# UNITED STATES PATENT AND TRADEMARK OFFICE

APPLICATION NO.	FILING DATE	FIRST NAMED INVENTOR	ATTORNEY DOCKET NO.	CONFIRMATION NO.
10/595,748	05/09/2006	Masaya Yano	UNIU79.069APC	5893

<b>Office Action Summary</b>	<b>Application No.</b> 10/595,748	<b>Applicant(s)</b> YANO ET AL.	
	<b>Examiner</b> JULIAN MERCADO	<b>Art Unit</b> 1795

## **DETAILED ACTION**

**PRIOR ART**

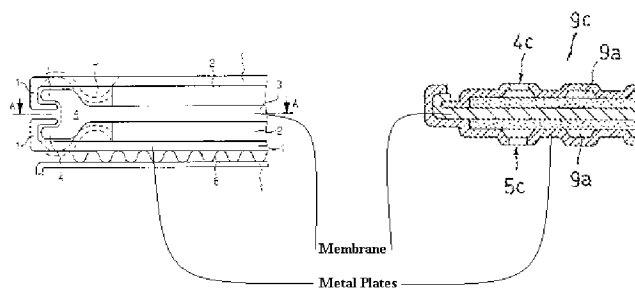
Notwithstanding the 35 U.S.C. 112, first paragraph rejection of claim 9, Figure 1 of Brückner et al. is relied upon to shown that at the circumferential part the metal plates have a smaller thickness. The mechanical sealing (see col. 2 lines 40-48) is as follows:

According to an advantageous configuration of the invention, the edge of the membrane is grooved and/or U-shaped, and the edges of the two terminal plates are of the same configuration, likewise being grooved and/or U-shaped, so that the upper and lower terminal plates are hooked into the respective groove wall of the membrane edge. The membrane is made from a sealing material, so that a seal is formed as a result of the terminal plates being hooked into the groove of the membrane edge.

As to the mechanical sealing being "by bending press", a flow path groove "formed by press processing" or "formed by etching" or "made smaller by etching", these process limitations are not given patentable weight as the limitations do not give breadth or scope to the product claim. The claimed product appears to be the same or similar to the prior art product insofar as being a fuel cell having a circumferential part of its solid polymer electrolyte mechanically sealed by circumferences of metal plates. In the event that any differences can be shown by the product of the product-by-process claim, such differences would have been obvious to the skilled artisan as a routine modification of the product absent of a showing of unexpected results. *In re Thorpe*, 227 USPQ 964 (Fed. Cir. 1985). A comparison of the Figures is appended herein:
